BEFORE THE BOARD OF PATENT APPEALS **AND INTERFERENCES**

Application Number: 09/752,015 Filing Date: December 29, 2000 Appellant(s): PERTHOU, PETER

EXAMINER'S ANSWER

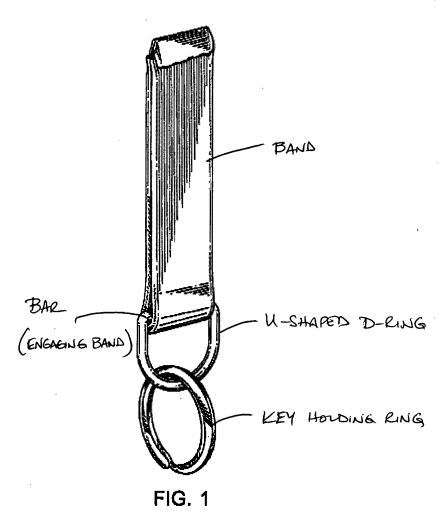
With respect to Appellant's specific arguments regarding the double patenting rejection on page 4 of the brief, lines 8-10 particularly, it is maintained that the D435,720 design patent clearly teaches the structure of the claimed invention as recited in the claims. For example in claim 1, the drawing figure 1 of D435,720 9as shown below)

clearly teaches a key holding ring at the bottom of the device, a band, a D-ring coupling the band to the key holding ring and the D-ring having a U-shaped portion engaging the key holding ring and a bar between the ends of the U-shaped portion and engaging the band. Accordingly, Appellant's arguments are not persuasive.
